Subject: Submittal of Revision 4 of the *Long-Term Surveillance Plan for the Maybell, Colorado, (UMTRCA Title I) Disposal Site*

Long-Term Surveillance Plan for the Maybell, Colorado (UMTRCA Title I) Disposal Site Moffat County, Colorado

April 2008

Figure 2-3. Disposal Site Map, Maybell, Colorado, Disposal Site

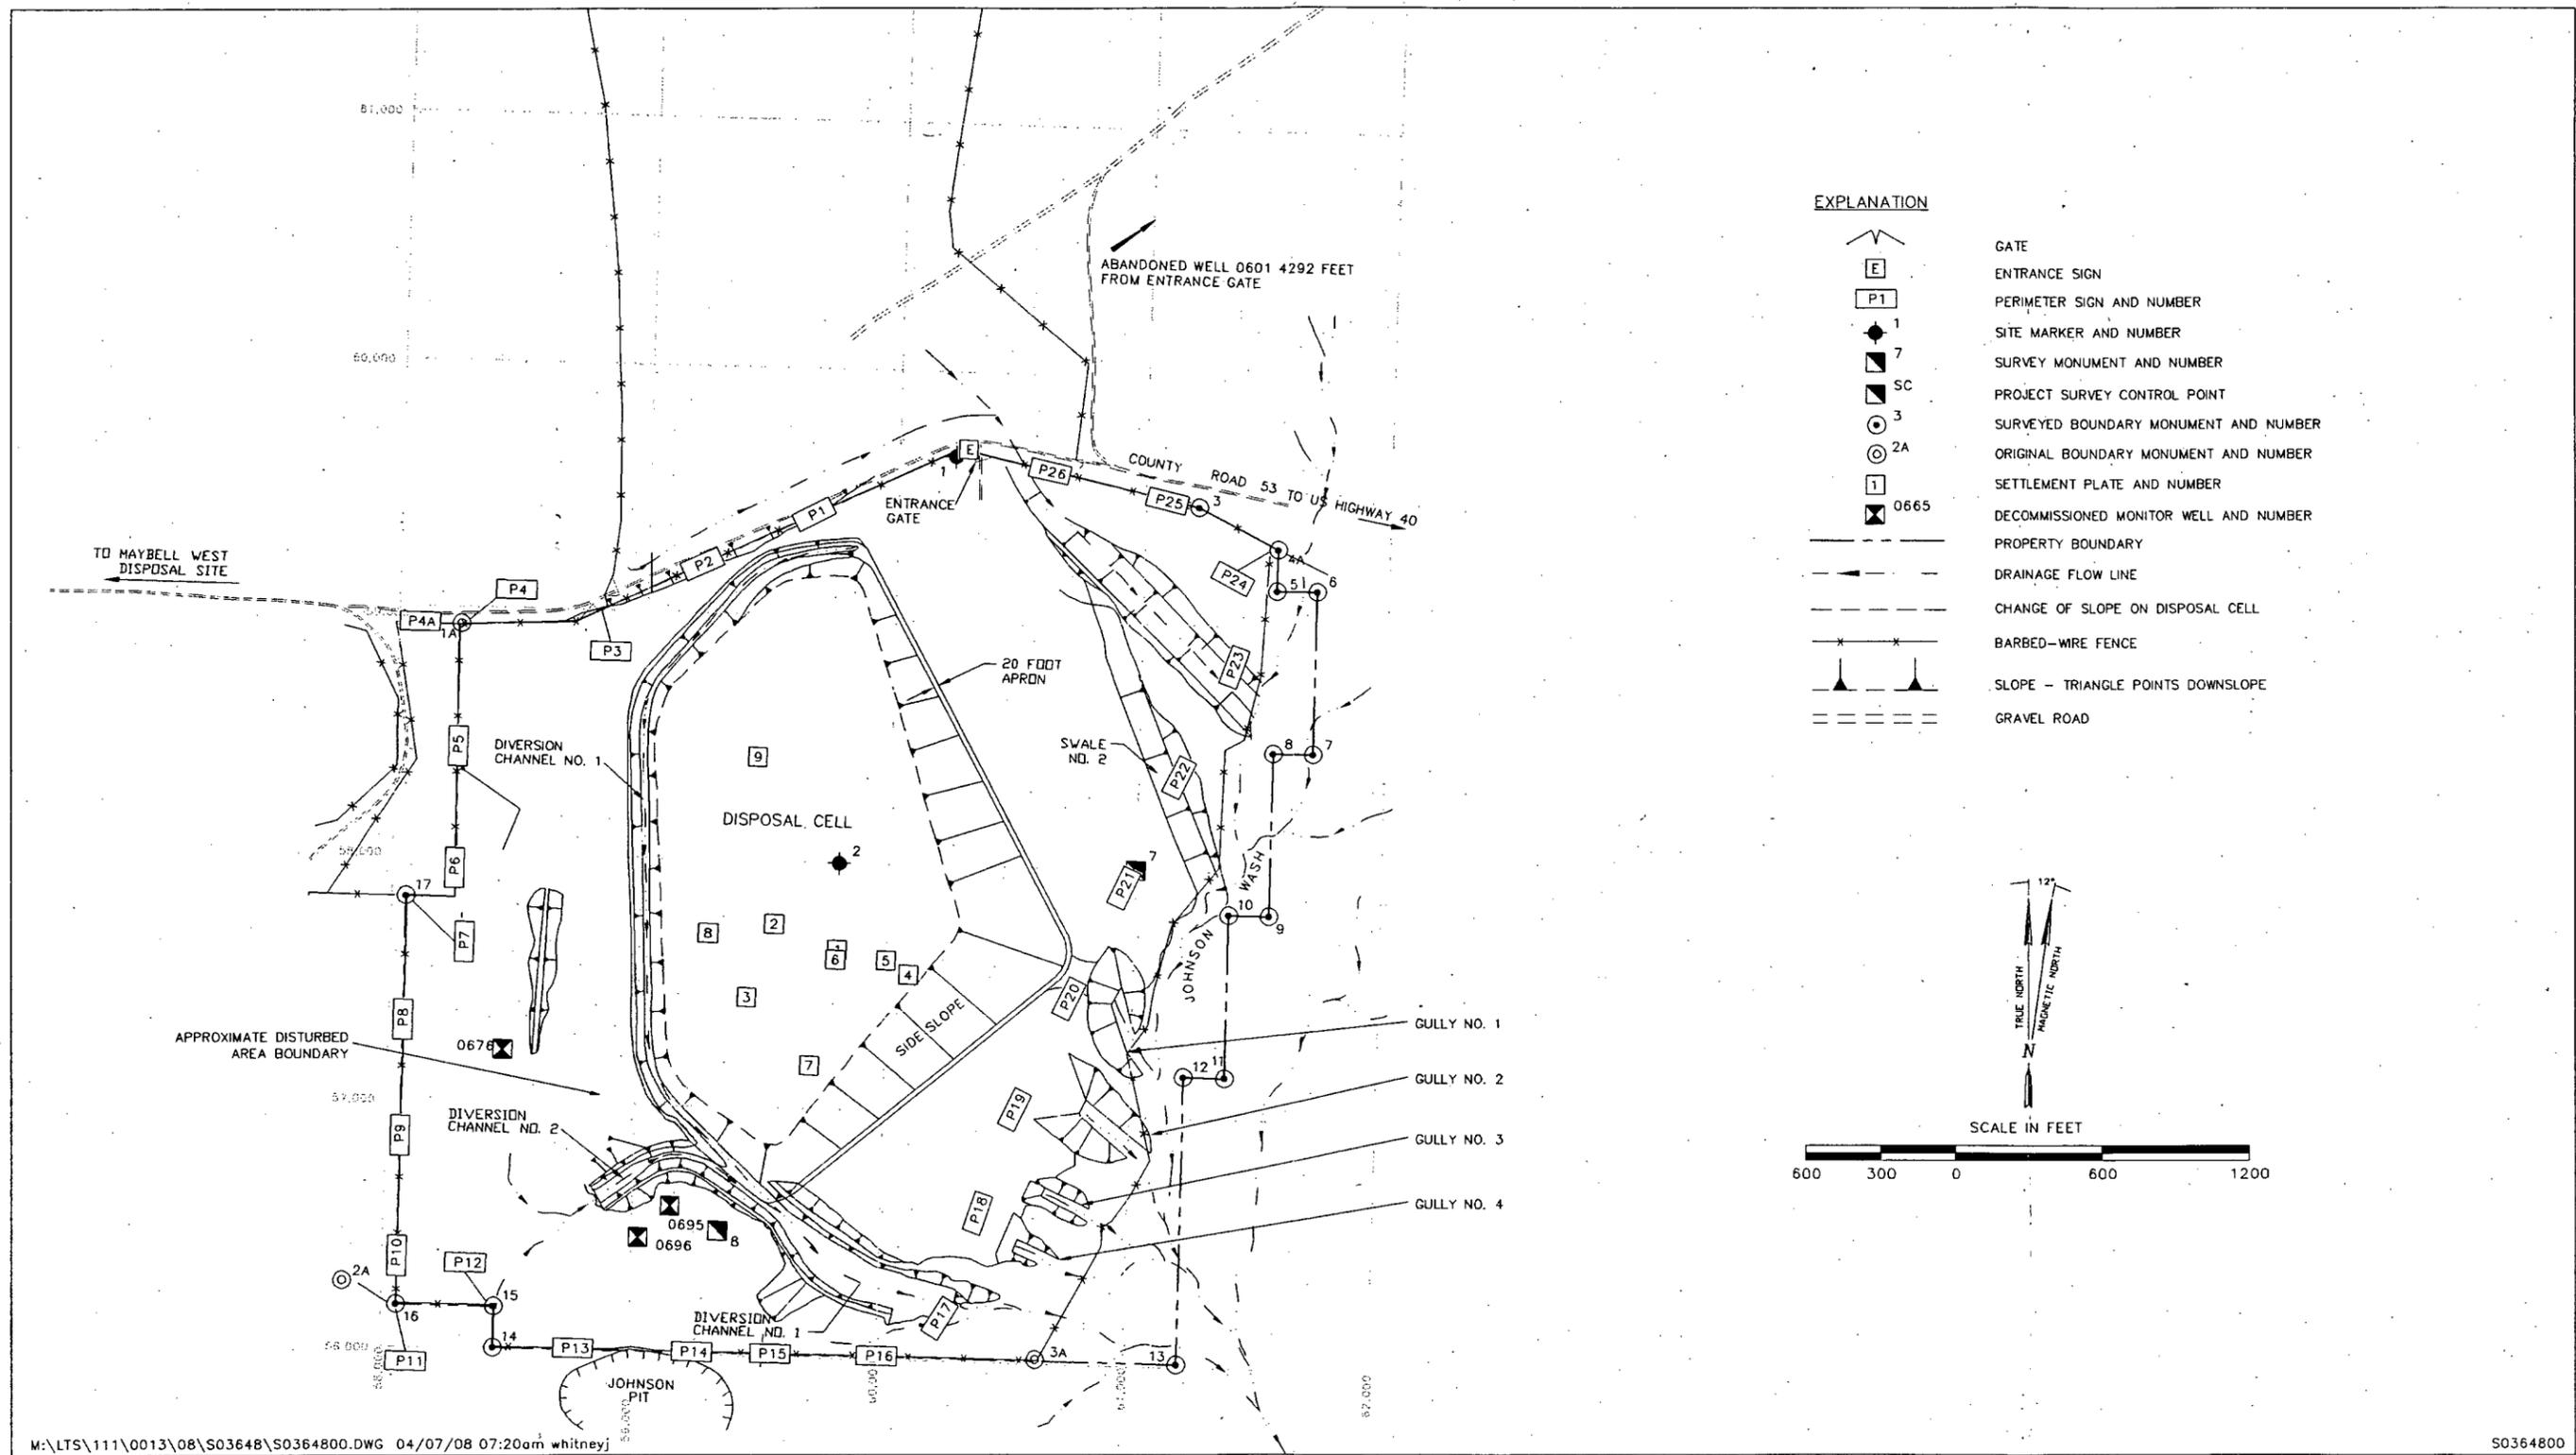
This April revision of the subject document (to correct the site boundary shown on Figure 2-3) replaces the November 2007 version of the LTSP that was revised to reflect the discontinuance of the best management practice ground water level monitoring program (as approved by your office per letter dated January 5, 2005).
